Memo

File No: DP09-0160
DVP09-0161

At: 3441, 3451, 3461 & 3471
Lakeshore Road

Purpose: TO OBTAIN A DEVELOPMENT PERMIT TO APPROVE THE FORM AND CHARACTER OF A MIXED-USE DEVELOPMENT

Exterior Elevation

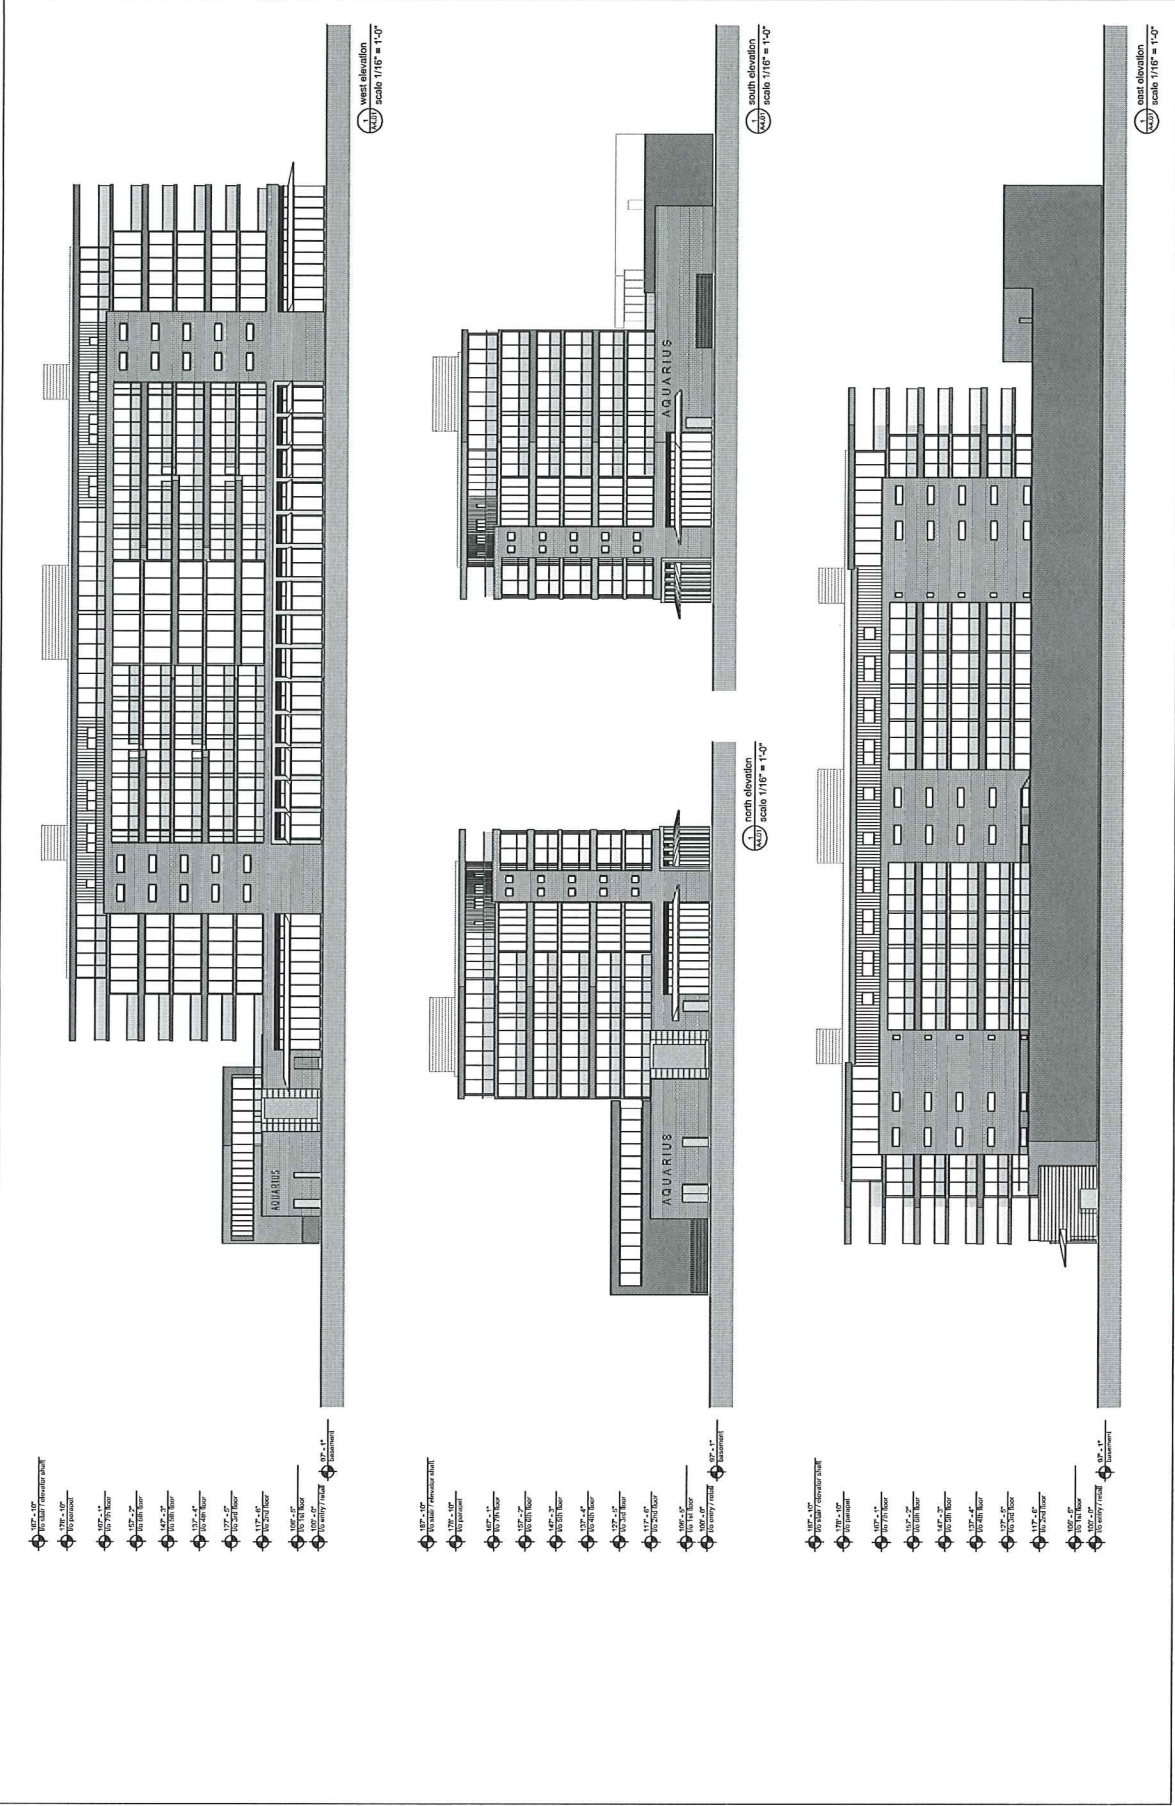
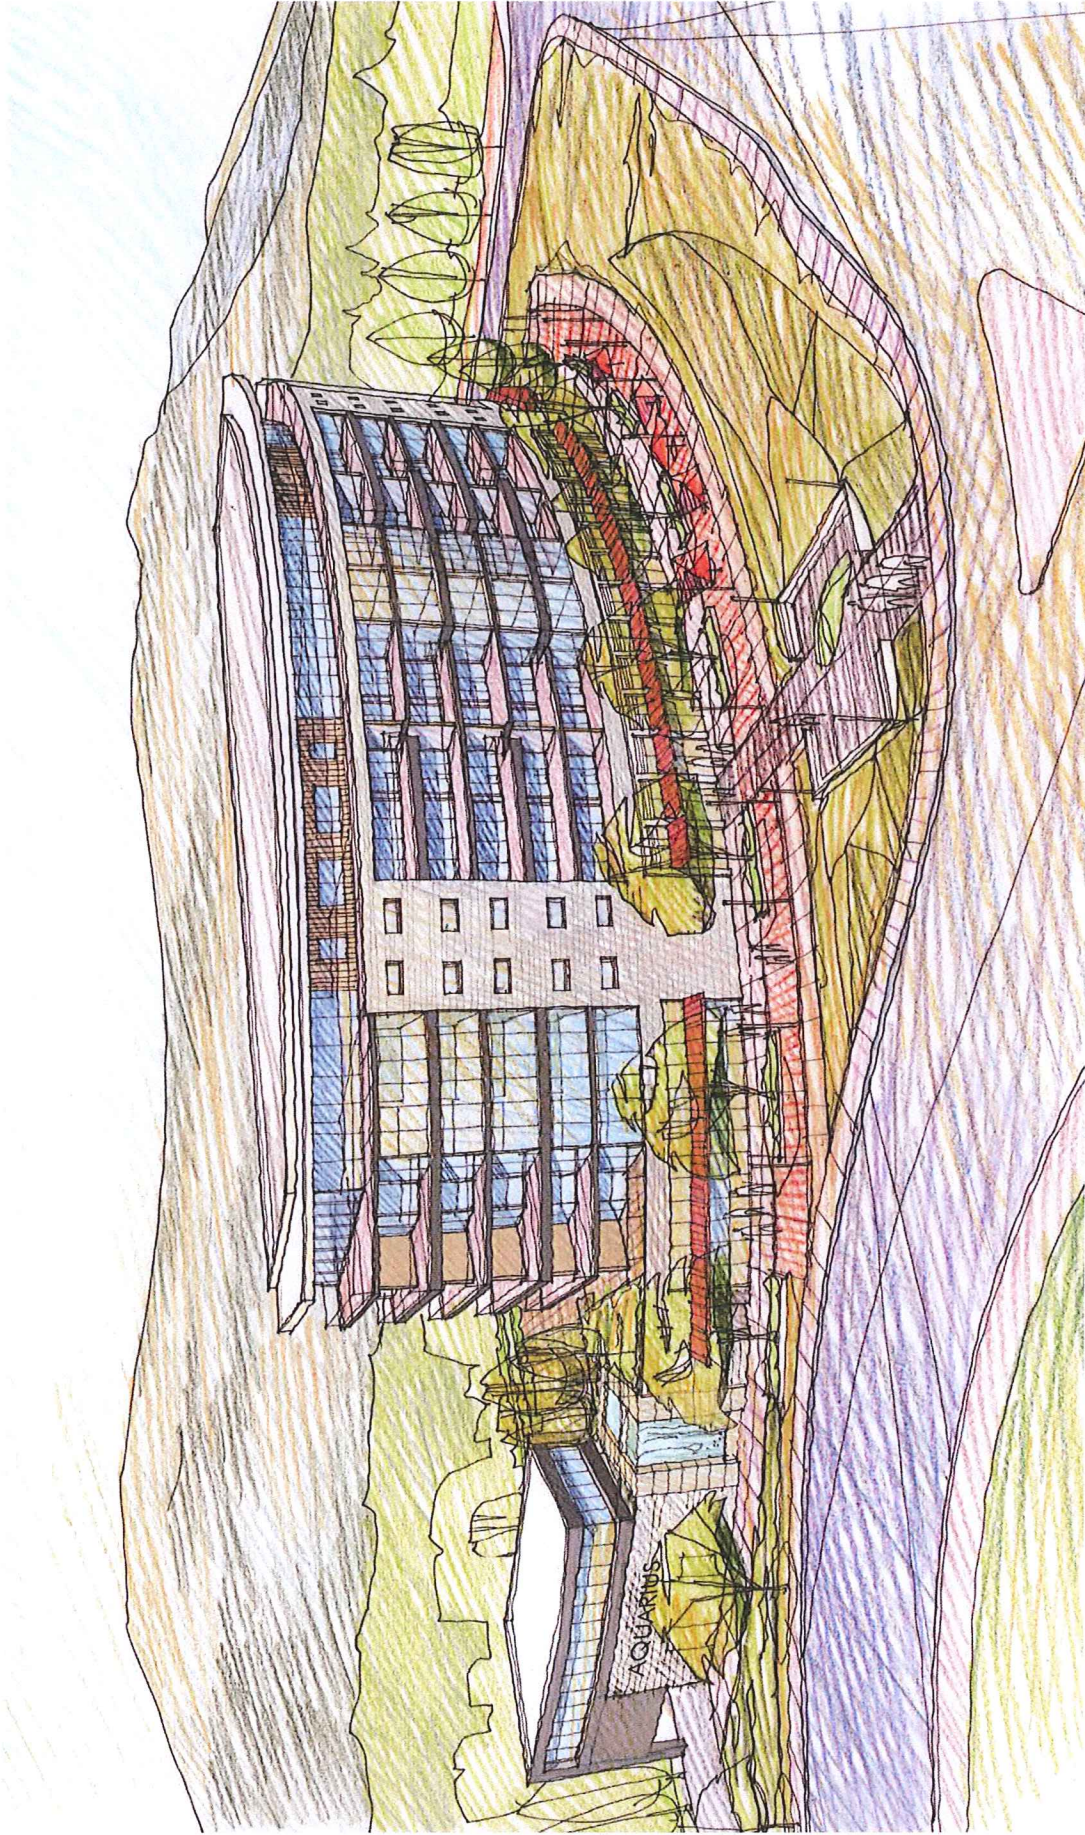
*VARIANCE REQUESTED FOR BUILDING HEIGHT
 (from 22.0m/6 STOREYS to 24.0m/7.5 STOREYS)
